SERVICE – BULLETIN

Reference-N°: KTSE - SB – 2102

Meter Panel Software Update

Model	Serial N°
KX060-5	See list at the end of the bulletin
U56-5	
U50-5

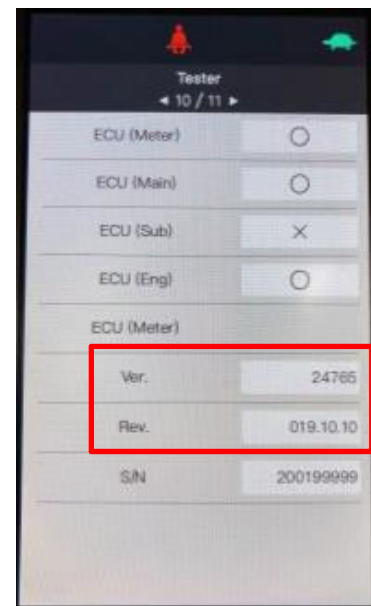
Verify that the version of the meter panel ECU software is updated.

The correct software version is:

Ver.	24769
Rev.	020.10.13

The RH illustration shows a software old version before the update.
